DEFINITIVE SUBDIVISION PLAN FOR COLTON ROAD EXTENSION

Definitive Subdivision Plan for Colton Road Extension
Post-Construction
Long Term Stormwater Operation & Maintenance Plan-Revision 1
August 10, 2020

**RE: *Response to Planning Director Questions, Comments
And Recommendations, July 16, 2020
Definitive Subdivision Plan Pre-Application Review 2
Colton Road Extension
7 Colton Road – Millbury, MA
ADE Job #3085.00***

RE: *Response to Engineering Peer Review Comments, July 13, 2020*
Colton Road Extension
7 Colton Road – Millbury, MA
ADE Job #3085.00

RIGHT-OF-WAY PLAN
FOR
COLTON ROAD EXTENSION
MILLBURY, MASSACHUSETTS
JUNE 10, 2020

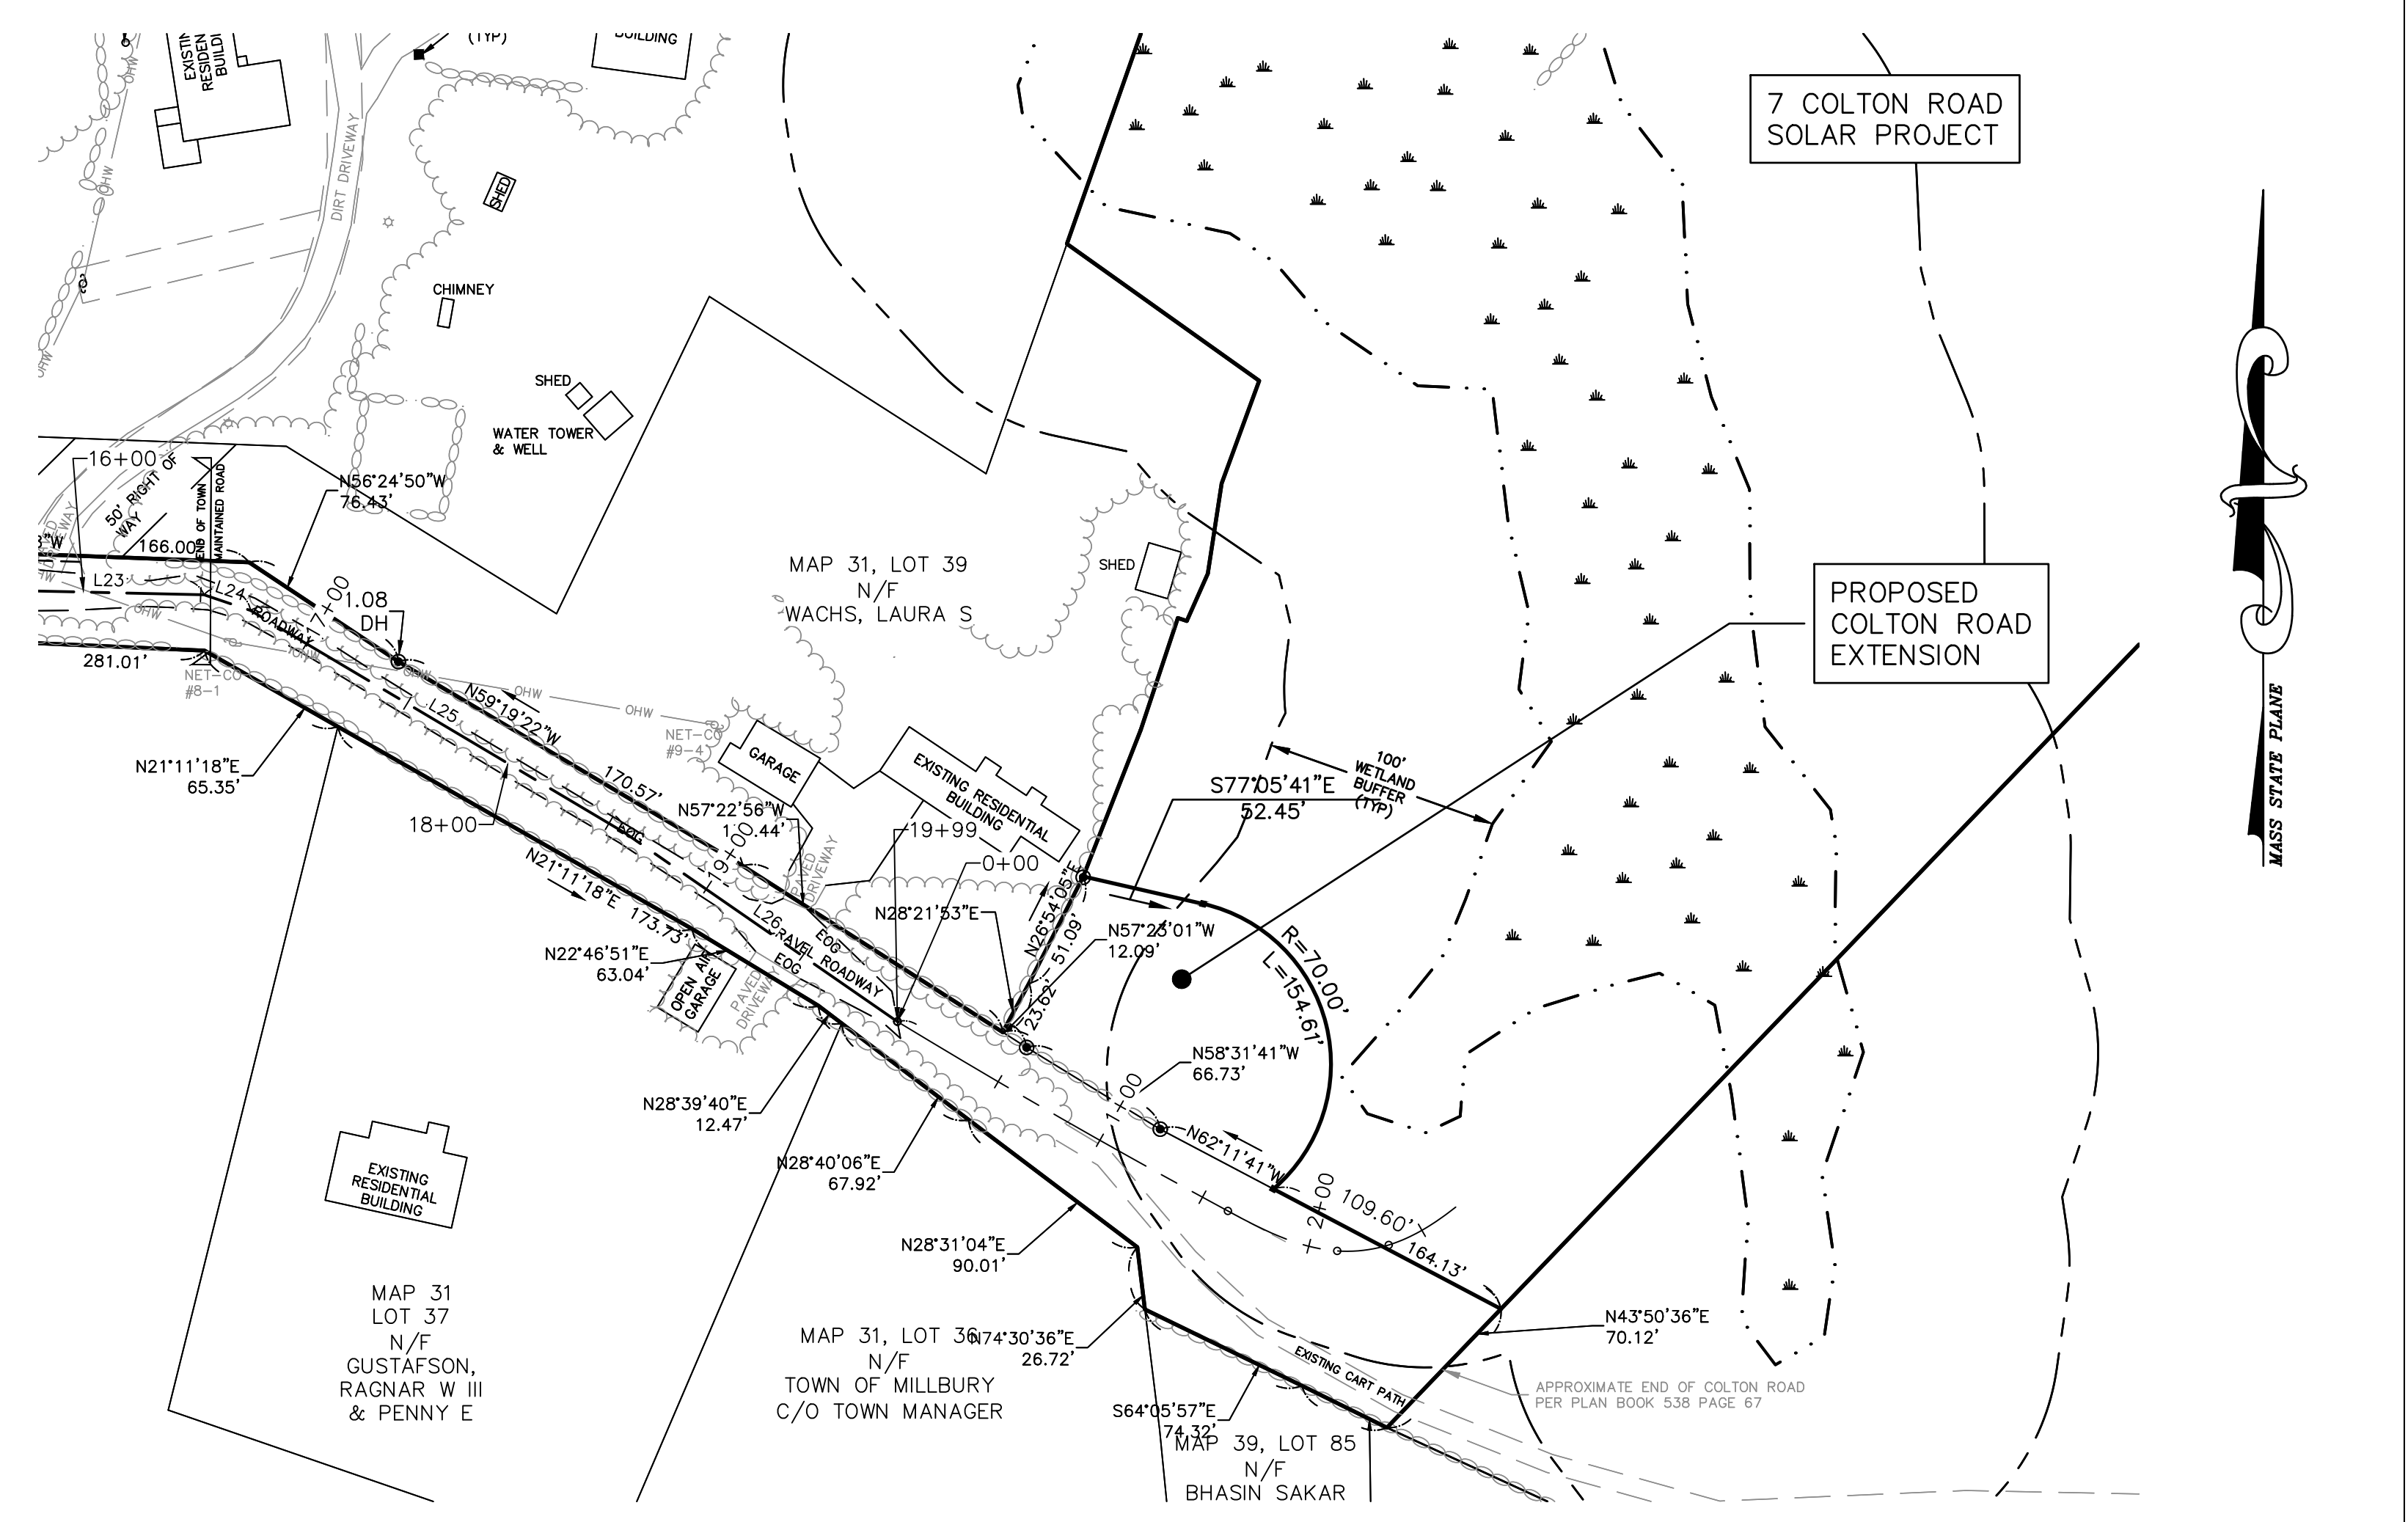
2d. We request a property line/right-of-way plan of "Colton Road" be submitted by ADE.

ADE Response: A Right of way plan has been added to the sheet set.

ROAD PLAN AND PROFILE STA 0+00 TO 8+50
FOR
COLTON ROAD EXTENSION
MILLBURY, MASSACHUSETTS
JUNE 10, 2020

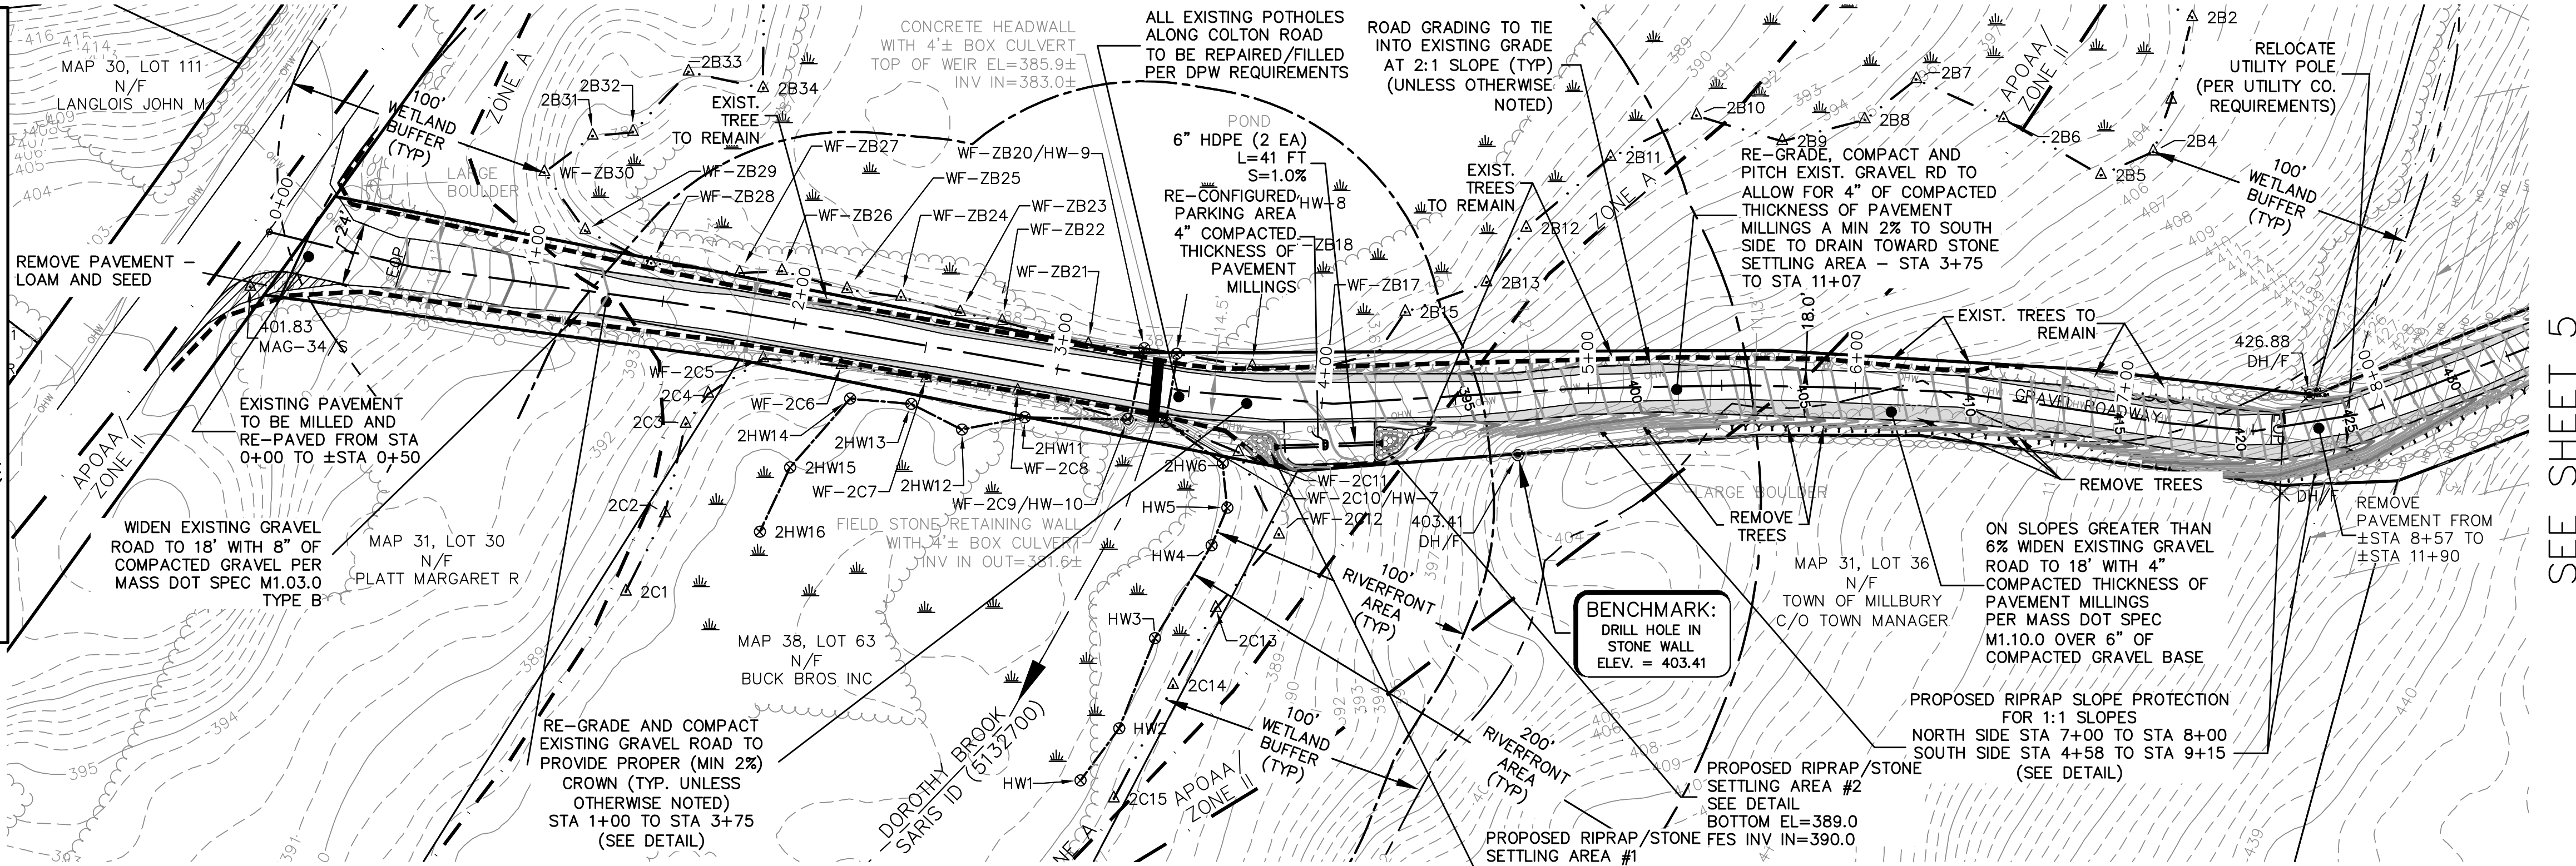
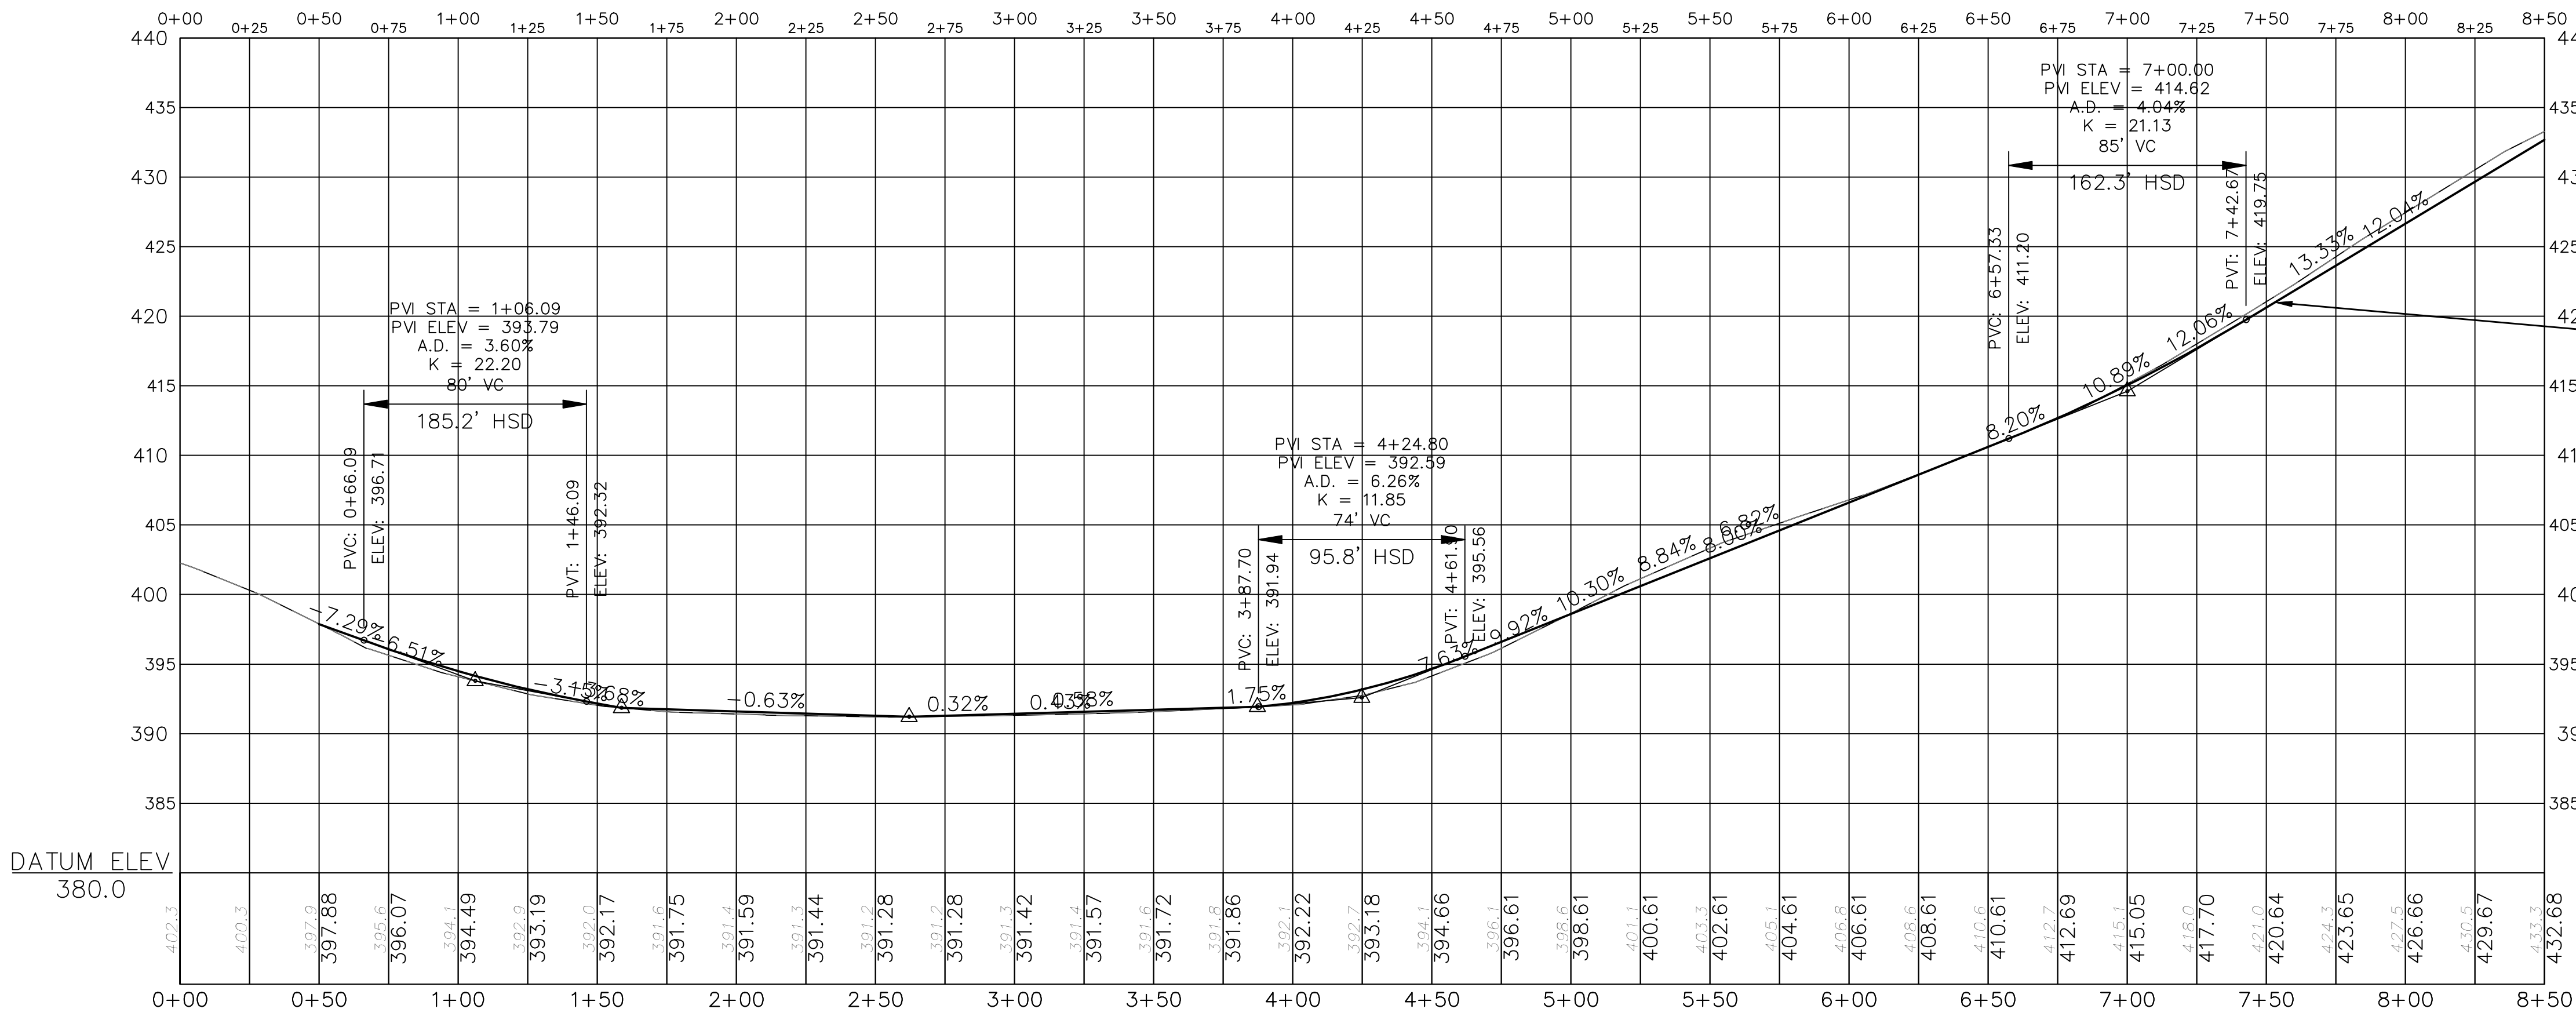
3. *The definitive plan shows that Colton Road will be regraded and widened to 18' with 8" compacted gravel per MassDOT spec M1.03.0 Type B. Where the grade exceeds 6%, the Applicant proposes to install 4" compacted thickness of pavement millings per MassDOT spec M1.10.0 over 6" of compacted gravel base. Subdivision Regulations, Section 7.2 requires 5" of*

4. It is my opinion that the improved section of Colton Road should be built on a 12” gravel base. That gravel base thickness is consistent with Subdivision Rules & Regulations, Section 4.2, which specifies the minimum standard for determining whether an existing way is sufficient for qualifying a plan as not constituting a subdivision. Also, existing roadway cross sections on Sheet 8 specify that only the widened portions of the roadway will contain the 4” compacted thickness of millings where the roadway grade exceeds 6%. I recommend that the Planning Board require the entire road width to consist of 4” compacted thickness of millings where the roadway grade exceeds 6%. The Plan should be revised accordingly.

We recommend proposed erosion and sedimentation controls be identified on plan and profile sheets 4, 5 and 6 associated with “Colton Road”.

4. As per the Board’s Design Standards, roadway vertical curves shall be designed to provide a minimum stopping sight distance of 200 feet. We recommend the proposed stopping sight distance be labeled at each roadway tangent. No vertical curves are provided along the proposed centerline roadway grades.

ADE Response: The plans have been updated to show 4” compacted thickness of millings the entire width where the roadway grade exceeds 6%.

ADE Response: Sediment controls are identified on sheets 4, 5 and 6 and are indicated with a dashed linetype. Sediment controls are located down gradient of the proposed work.

ADE Response: The subdivision regulations state indicates a preferred minimum stopping sight distance of 200 ft while 150 ft may be permitted. All proposed vertical curves along Colton road have a stopping sight distance of over 150 ft with exception to the vertical curve located at approximately 19+40. At this location we anticipate traffic to be limited to 4 trips per year for the solar project and anticipate a max speed of 15 mph. Stopping sight distance for this speed from FHWA AASHTO’s Signalized Intersections Information Guide indicate a design distance of 80 ft (minimum) should be used. The current design is providing 82.3’ of stopping sight distance. The applicant will request a waiver for this.
